9 April 2014

**A1 Haggerston, Northumberland
In relation to the Death of Mr Samuel Eric Shaw**

Unlit A1

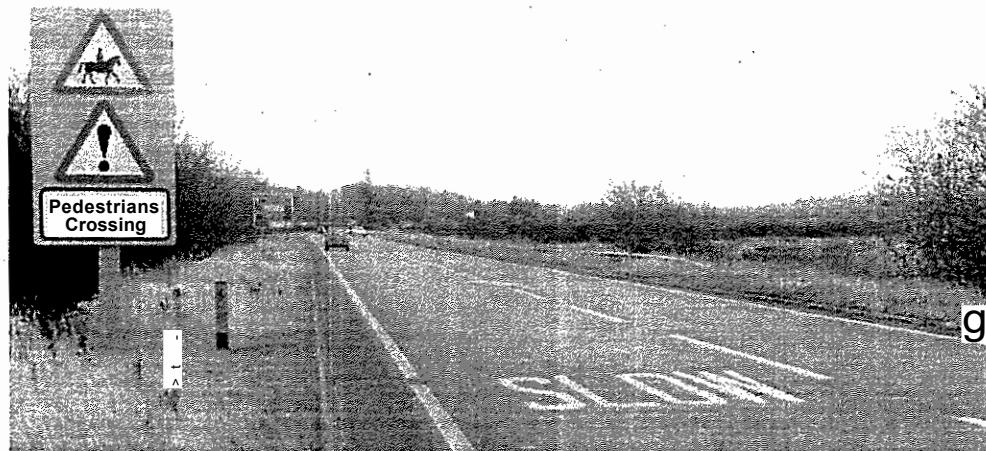
No street lighting has been provided on the A1 in the vicinity of Haggerston. This is not untypical for a length of rural de-restricted single carriageway road on the strategic road network. For your information, no street lighting exists on the A1 between Blagdon Interchange, to the south, and A1167 Scremerston Roundabout, to the north, a distance of approximately 50 miles.

The primary purpose of street lighting on the strategic road network is to reduce the risk of night-time personal injury accidents. The latest available 5-year accident record (the period most frequently used when assessing accident sites and trends) confirms that two slight night-time collisions have also taken place, on a km length including this junction.

Bearing in mind the Government's target to reduce carbon emissions; the introduction of new street lighting schemes are currently being given a comparatively low priority, and only considered at sites where a significant problem exists.

Photograph 1: Warning signs and road markings on the A1 southbound approach to the junction.

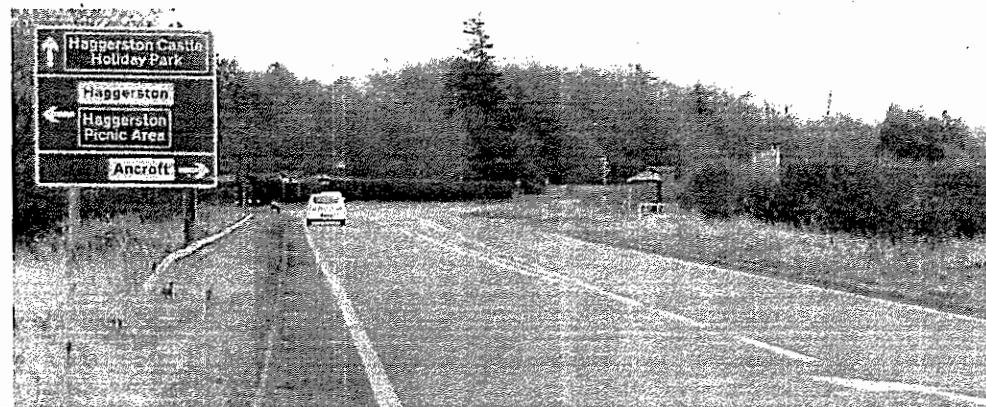
Your report indicates that there are no warning signs on the A1 southbound approach to Haggerston. I can, however, confirm that signs have been in place since 2005 comprising an 'Accompanied Horses Crossing' warning sign, an 'Other Danger Ahead' warning sign with 'Pedestrians Crossing' worded supplementary plate, on a bright yellow backing board. These signs exist on both the north and southbound approaches to the crossing location at appropriate distances from the hazard. These signs are associated with a SLOW road marking laid on a red coloured carriageway surface patch, to further highlight the hazard ahead. Please see Photograph 1 below.

I have concluded that the lighting and signing provision meets current standards and therefore no immediate action is required to address your concerns.
